ANN ARBOR HISTORIC DISTRICT COMMISSION

Staff Report

ADDRESS: 519 Sixth Street, Application Number HDC21-130

APPLICATION: The applicant seeks HDC approval to install a gas meter on the south side elevation, three feet from the southwest corner of the house.

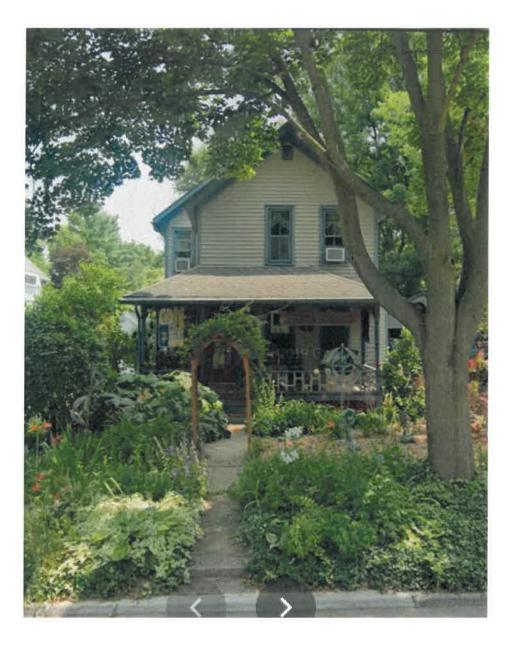
- 2. The application states that the meter is unable to be moved farther back and maintain less than 10' of fuel line. It says the meter manifold will have minimal visibility from the street due to an existing tree.

- 3. The application includes a photo of a post mounted meter. The post mount is appropriate because it does not touch historic materials the way a bracket (the alternative) installed on the house does.
